**POTENTIAL EXPLORATION, DEVELOPMENT, AND PRODUCTION OF
OIL AND GAS RESOURCES; VANDENBERG AIR FORCE BASE, CALIFORNIA**

FINAL ENVIRONMENTAL IMPACT STATEMENT

The final EIS relies upon the analyses provided in the draft EIS. It does not repeat draft EIS information. It provides erratas for the EIS, Air Quality Technical Appendix, and MRMP. In addition, public and written comments on the draft EIS and responses are provided.

Figure 3.2-1A
WATER WELL LOCATIONS

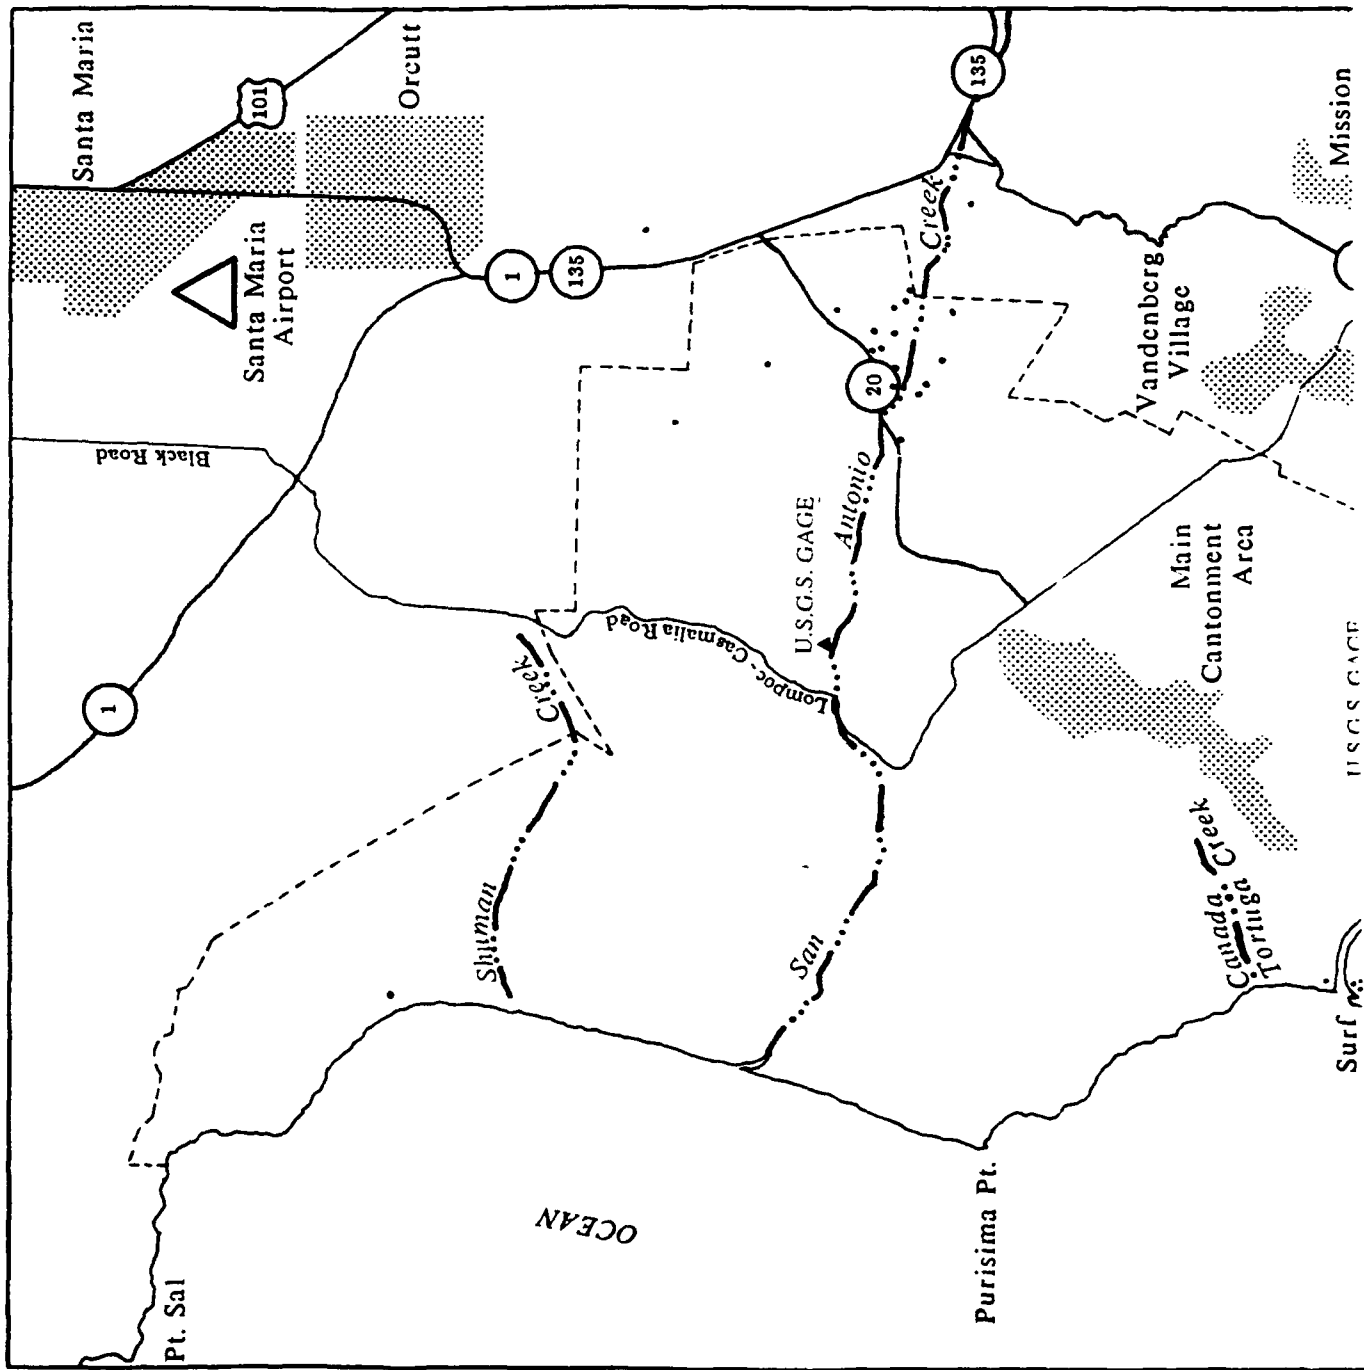
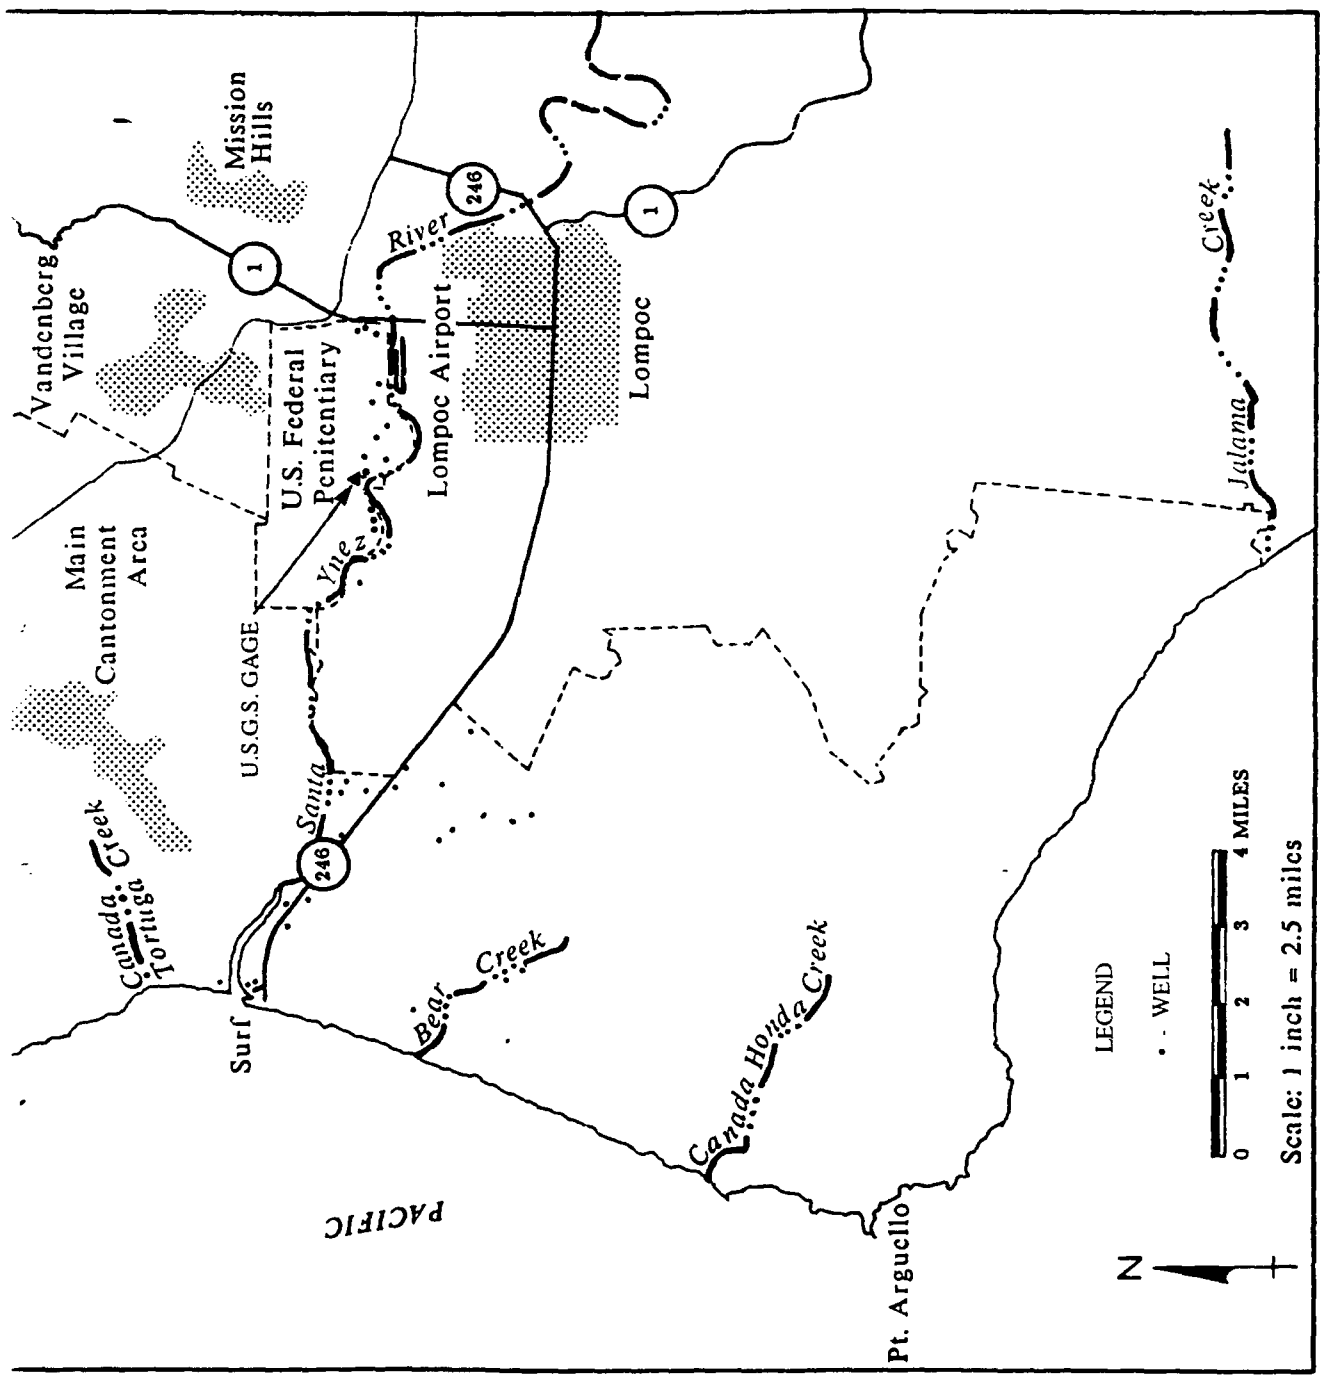
Section 3.2.4.1.2; page 3.2-8, add the following sentence at the end of paragraph one: "Water well locations are shown in Figure 3.2-1A." See the attached figure.

WQCB-5 Surface water and groundwater features are delineated in figures 3.2-1 and 3.2-2 of the DEIS, respectively. Water well locations are displayed on a new figure (Figure 3.2-1A of the errata for the EIS).

Figure 3.3-2
SANTA BARBARA COUNTY AIR QUALITY
MANAGEMENT REGION

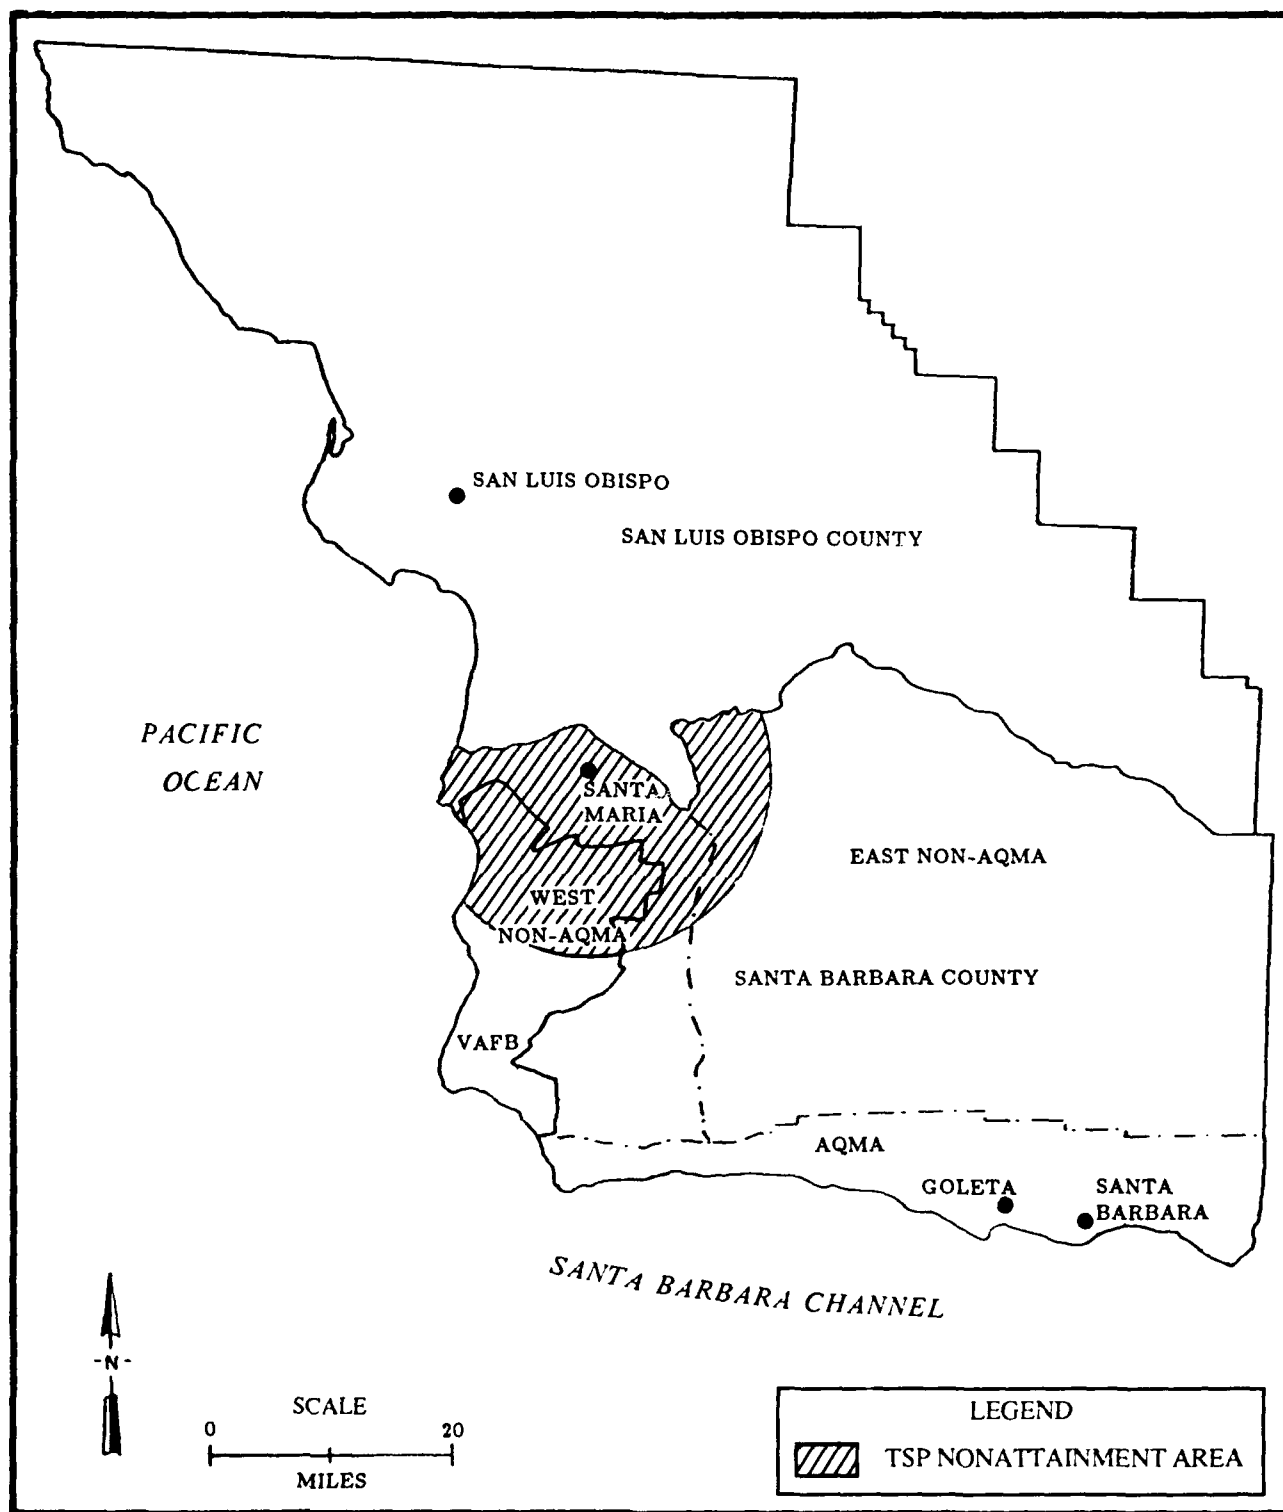
1. The TSP non-attainment area described on page 3.3-7 and depicted in Figure 3.3-2 mistakenly includes a portion of southern San Luis Obispo County. No areas in San Luis Obispo County are currently designated as Federal non-attainment areas for any pollutants. TSP measurements at Nipomo are well within Federal standards. The Nipomo monitoring station is located approximately nine miles north of Santa Maria. This correction should be noted in the FEIS.

Page 3.3-9, the TSP nonattainment area in Figure 3.3-2 has been corrected to only include the 15-mile radius from Santa Maria that is within Santa Barbara County.

Figure 4.9-3
STEAM GENERATOR

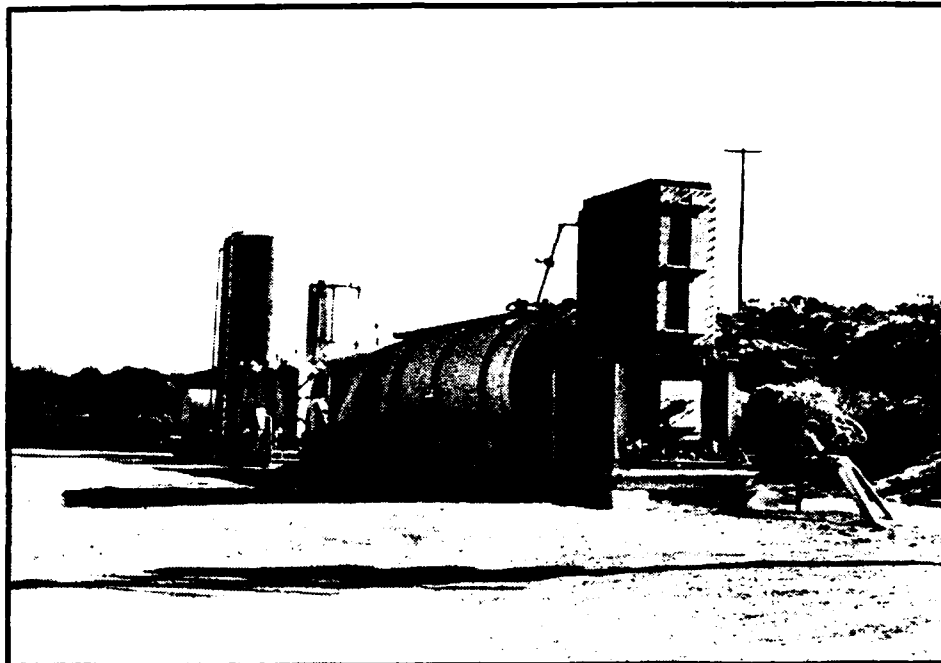
Figure 4.9-3 is incorrectly titled "H₂S Scrubber". This photograph actually depicts a steam generator.

Figure 4.9-3 on page 4.9-5 has been retitled "Steam Generator" as shown on the attached figure.

Figure 5-1
PHYSIOGRAPHIC FEATURES
MRMP-2

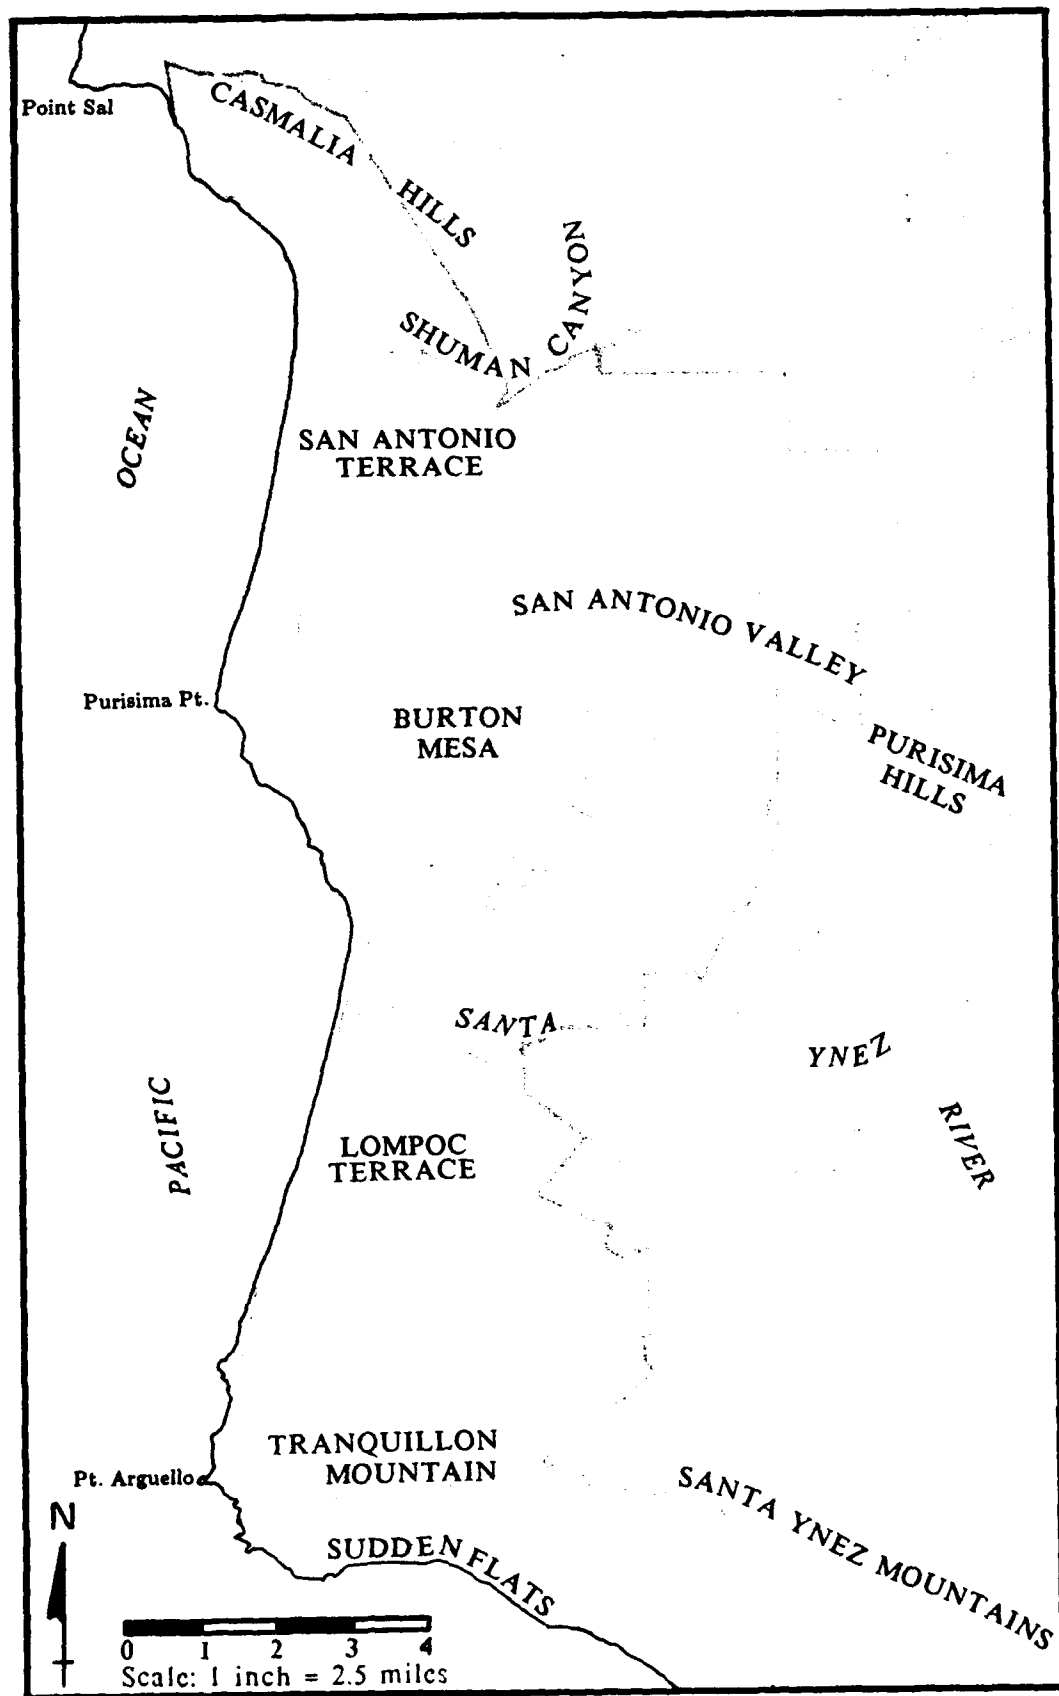
Figure 5-1 - Point Conception is incorrectly located

Figure 5-1 on page 5-2 has been revised. The words "Point Conception" no longer appear (see the attached figure).

Figure 6.5-3
INITIAL COMPLIANCE ACTIVITIES

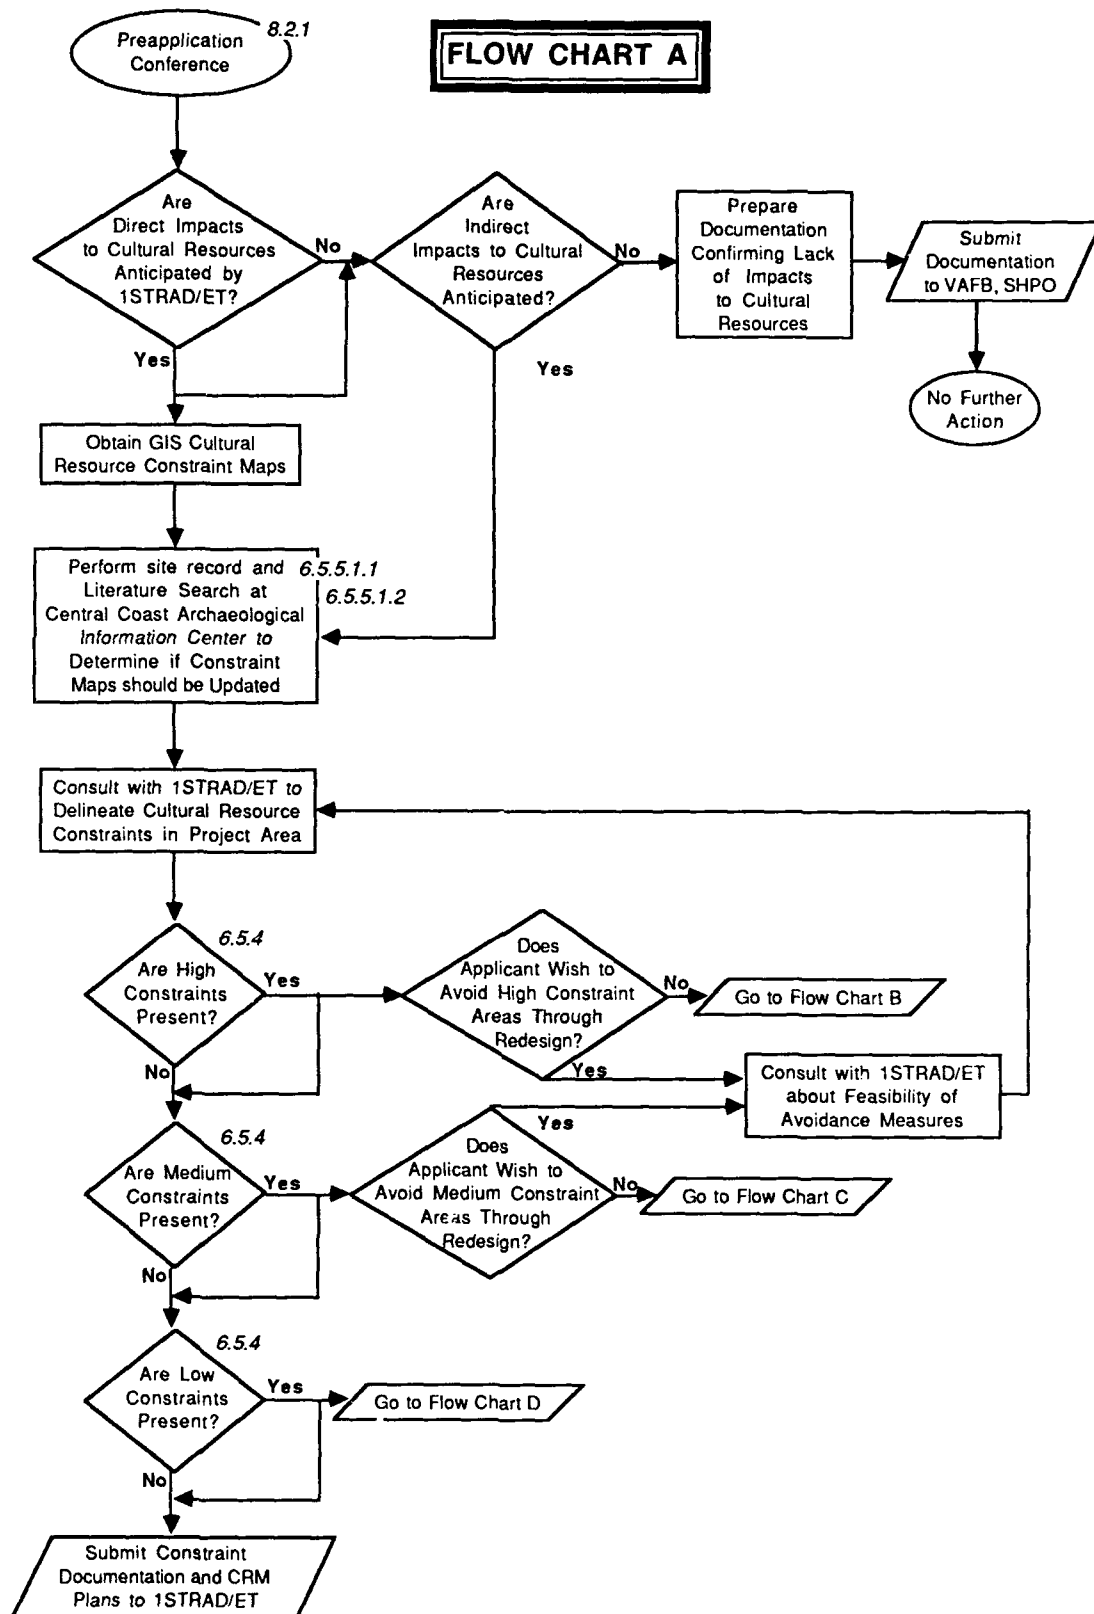
The comment also states that the MRMP does not allow for modification of individual project designs to avoid extensive and expensive site investigations. In fact, the MRMP explicitly sets out compliance activities that focus on avoidance of impacts through redesign *prior* to excavation. For example, Figure 6.5-4 (Flow Chart B) of the MRMP indicates that if a site is present in a project area, it should be avoided through project redesign if possible. Misunderstanding of the procedures may have arisen because this flow chart shows that site avoidance would take place after site boundaries are defined. This is the normal procedure when a redesigned area of potential environmental impact (APEI) is near a site. However, if a project could be redesigned so that the APEI would no longer lie near a known cultural resource, ISTRAD/ET might decide that boundary definition is not necessary. See section 6.5, Cultural Resources, of the MRMP errata for a discussion of when boundary definition may not be necessary.

investigations. Project applicants should consult closely with the U.S. Air Force so that project redesign can be initiated as early as possible. Figure 6.5-3 (Flow Chart A) of the MRMP has been modified to show that avoidance can be implemented after the preapplication conference between the U.S. Air Force and project applicant and before boundary definition is necessary. In this way, an efficient process would be assured. Please see the MRMP errata for section 6.5, Cultural Resources.

Page 6.5-22, Figure 6.5-3 is replaced with the attached.
